Optimisation of the air suspension bracket for FB100 air suspension units

Progressively starting in the 2nd quarter of 2023

- This TM02/2023 is a supplement to the installation guidelines GN0040-2 for air suspension units FB100.

Air suspension bracket with drain holes starting in the 2nd quarter of 2023

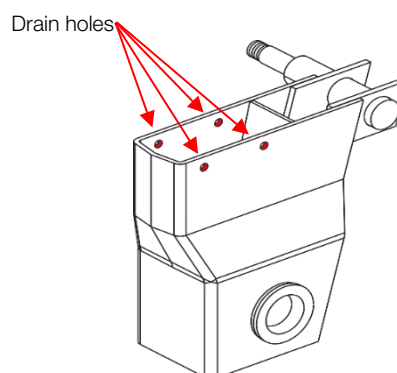
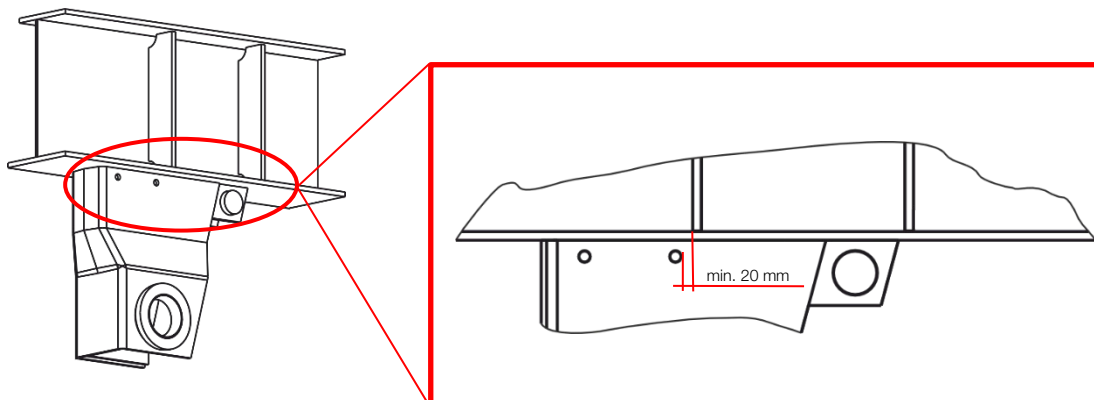
- Two drain holes with a diameter of 11 mm will be added on each side of the air suspension bracket approx. 15 mm from the upper edge.
- When positioning the lateral supports or reinforcements plates on the chassis, it must be ensured that they are placed at least 20 mm away from the drain holes.
